# Product Change Notification

**Product Change Notification:** E-19-000377

<b>General Product Description:</b>
MQS socket contact

E-19-000377						
Product Engineering						
Document Classification						
Not necessary						
<b>C-929454</b>						
C22						
MQS socket contact

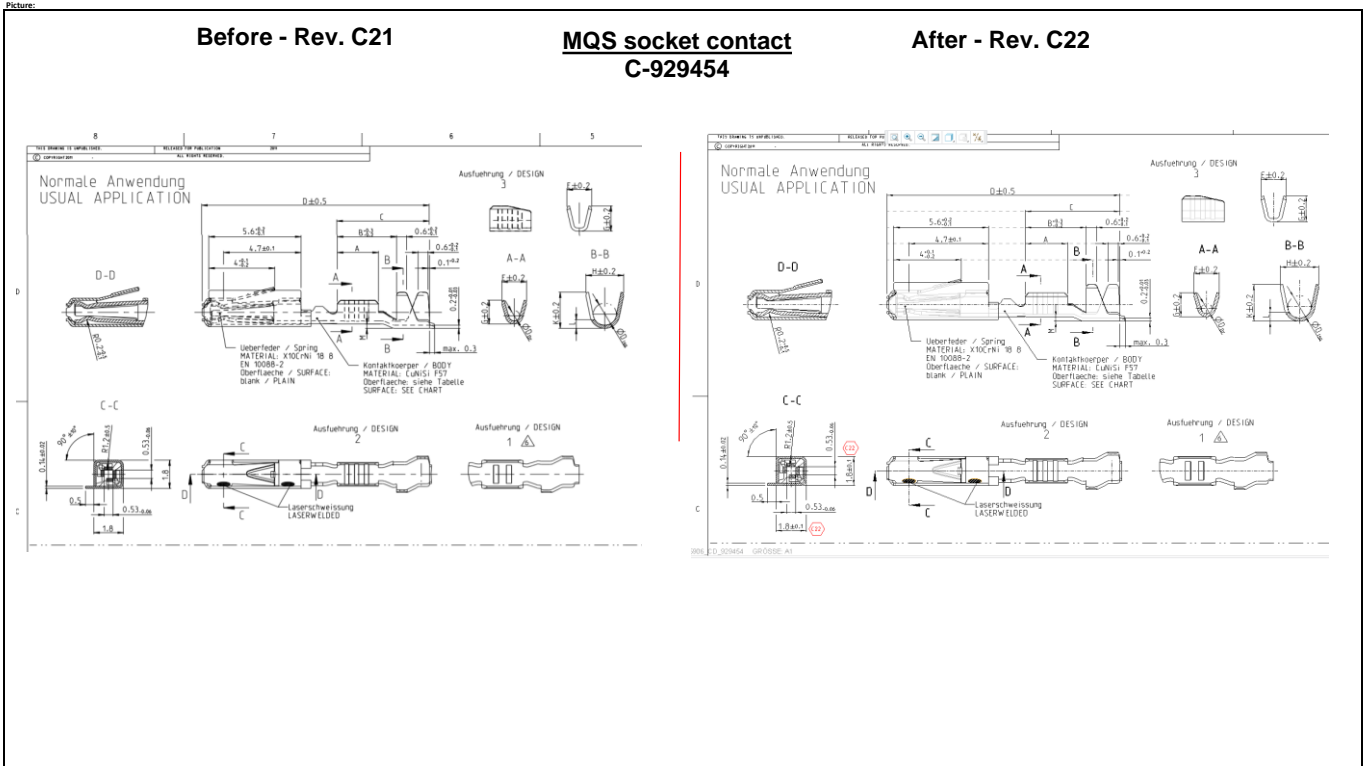
<b>Description of Changes</b>
Tolerance change from general +/-0.2 to specific +/-0.1 for dimension 1.8
<b>Other attachments:</b>
<a href="#">E-19-000377</a>

X	Potential Impact for Customer	X	Product Type	X	Change Type	X	Kind of Change	X	Change Feature	Remark / Free text
		X	Contact	X	Drawing	X	Drawing Change	X	revision adapted	Tolerance change from general +/-0.2 to specific +/-0.1 for dimension 1.8
